**JOINT ARCHITECTURAL BOARD/PLAN COMMISSION AGENDA**  
**MONDAY, AUGUST 21, 2023**  
**6:30 PM**  
**BOARD ROOM, MUNICIPAL BUILDING, 210 COTTONWOOD**

3. Plan Commission will conduct a review of Onyx Hotel, a proposed PUD development ("Project") whose approval and rezoning is being sought by James Kupfer on property tax key HAV0729116 located at 221 Cottonwood Avenue. The Plan Commission will review:

BASIC INFORMATION	
Project Name	Onyx Hotel
Applicant Name	James Kupfer/Adam Hertel
Consulting Planner and/or Engineer	American Architectural Group/Parish Engineering
Existing Zoning	RS-5
Requested Zoning	None yet
Address/Abbreviated Legal	Tax Key HAV 0729116
Comprehensive Land Map Designation	Downtown Mixed Use

Sheet Title:  
RAMP SECTIONS

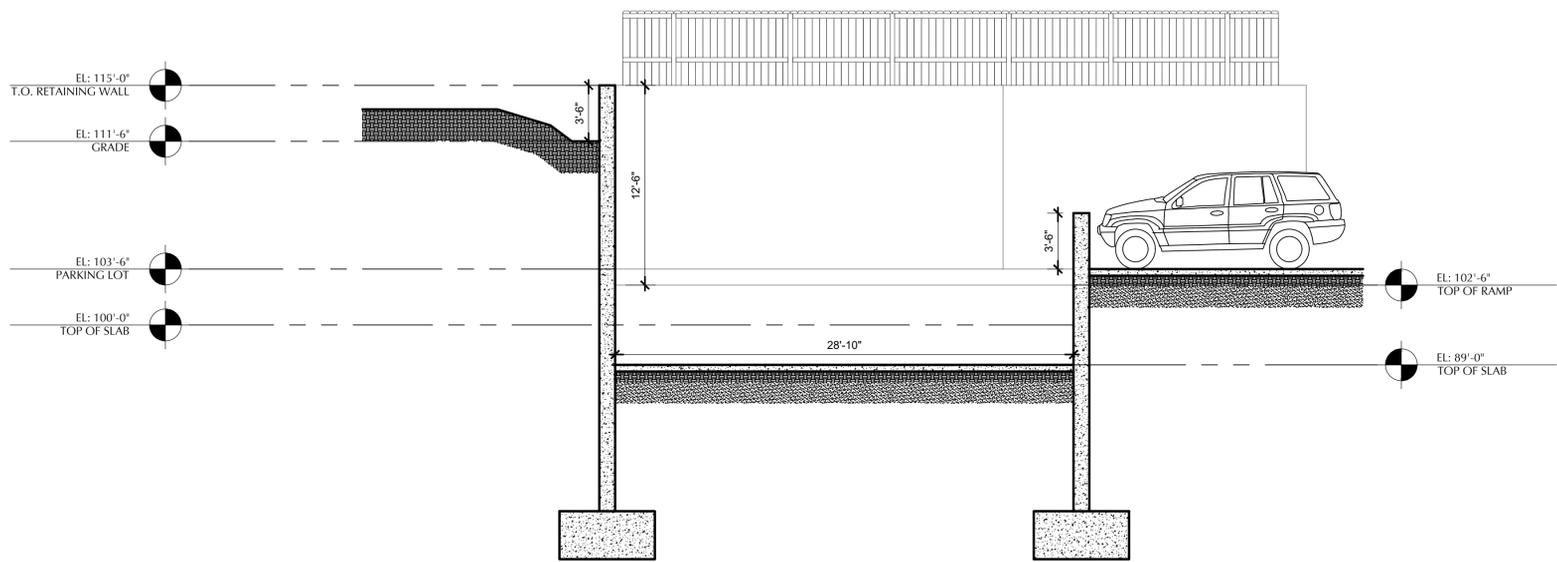
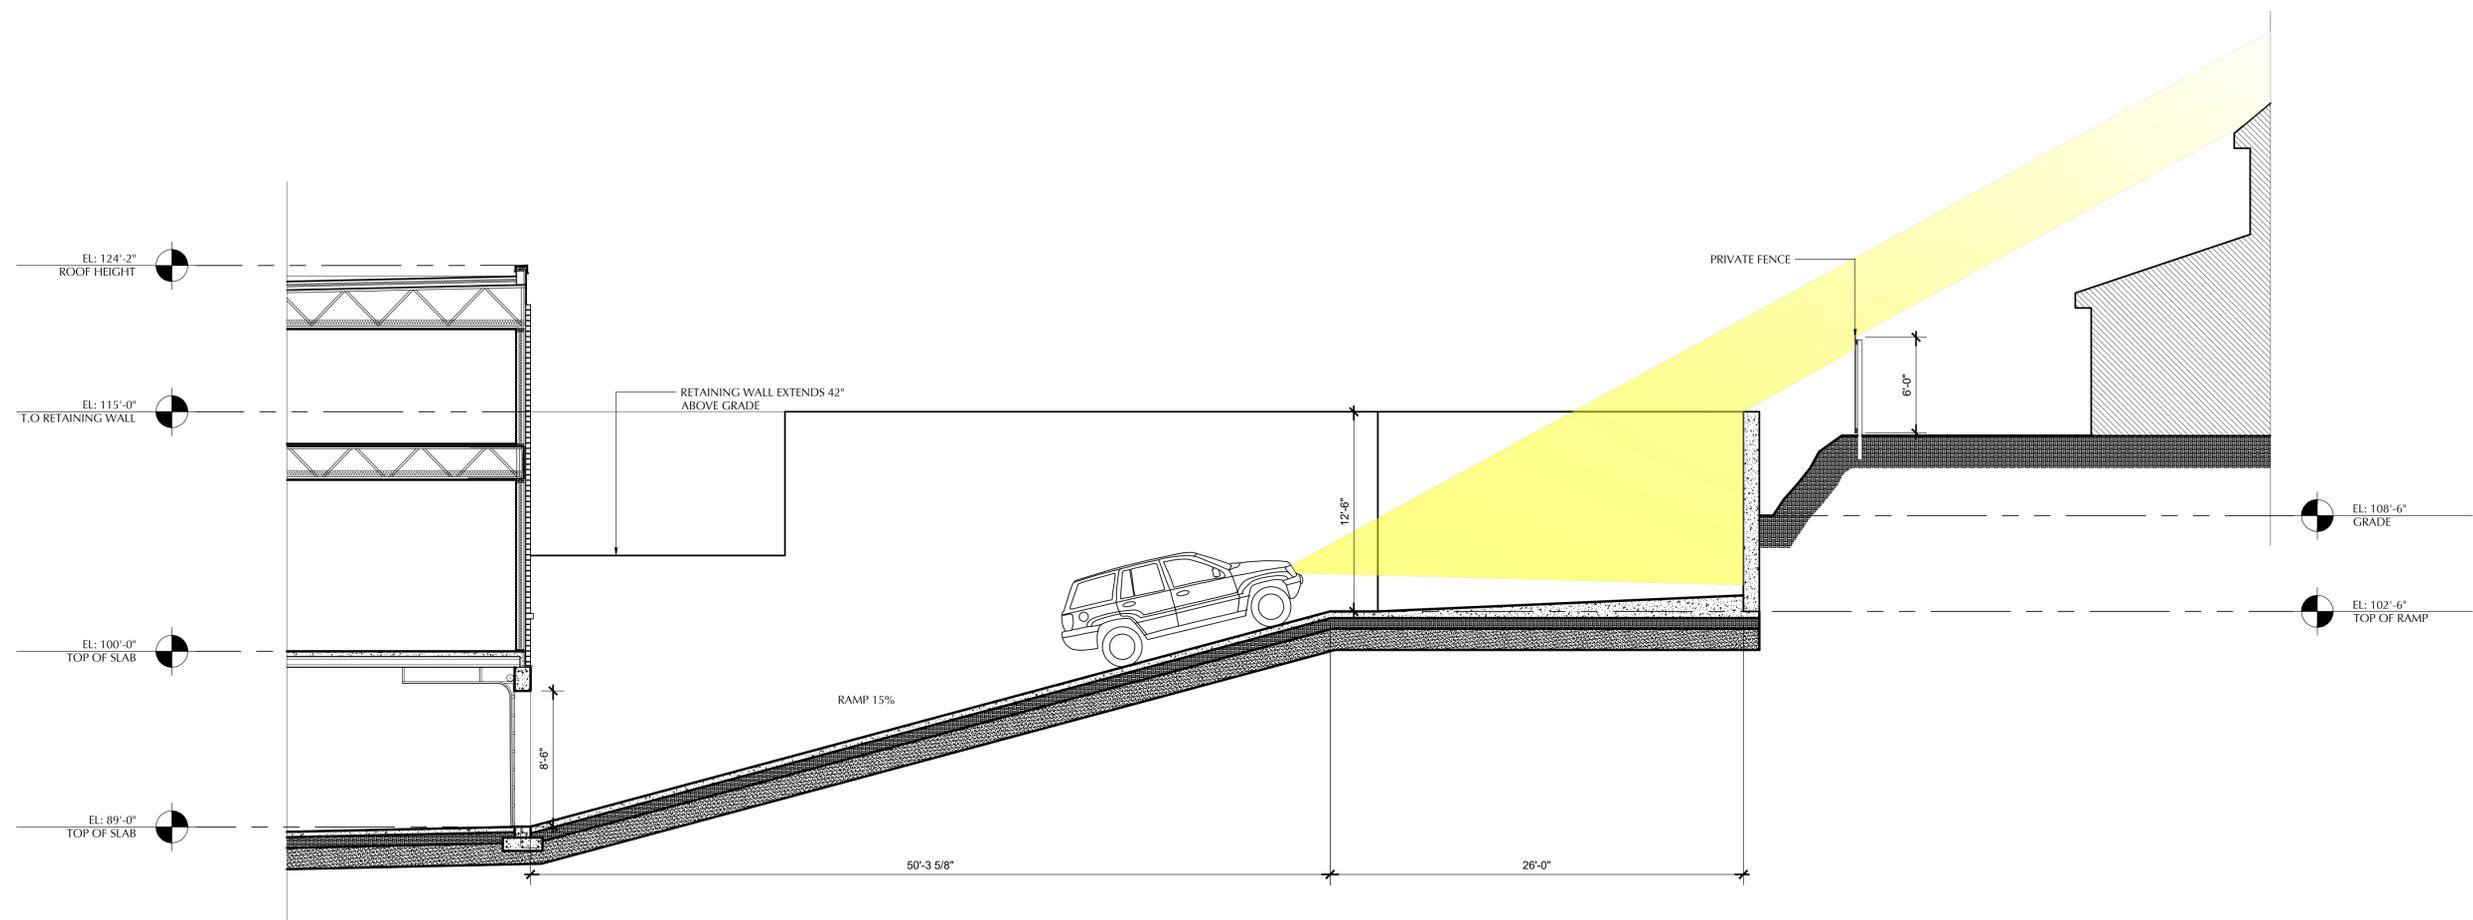
- a. Railing/fencing on top of retaining walls?
  - b. Need soil borings for retaining wall design. Wall design to be stamped by structural engineer. Will upland areas of retaining wall capture overland drainage and come out through the drain pipes at bottom of walls? Is this factored in storm water calcs?
